Delegated Report

Approval of Details

Planning Application No:	20240164
Location:	18 Marks Square Northfleet Gravesend Kent
Description:	Application for the approval of conditions 5 and 7 attached to planning permission reference number 20220590 relating to full details of the new boundary treatments to the site including any retaining structures (5) and full details of soft landscaping within the garden area of the existing dwelling (7).
Applicant:	Mr Lewis Brown
Site Visit Date:	28 March 2024

Indicative suggested tall boundary line with anything in front restricted to ideally 700mm above footway level. This equates to a 33 metre sight line suitable for 25mph.

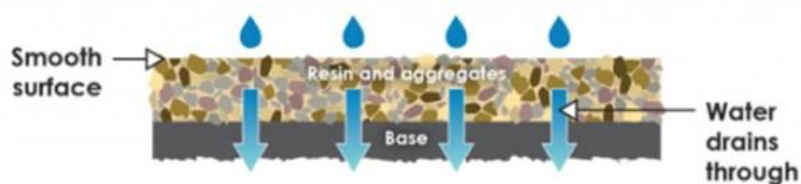
It is therefore suggested, whilst a low boundary wall is acceptable, ideally anything over 0.7 metres above carriageway should be restricted to behind the sight line requirements for 25 mph or 33 metres for both accesses.
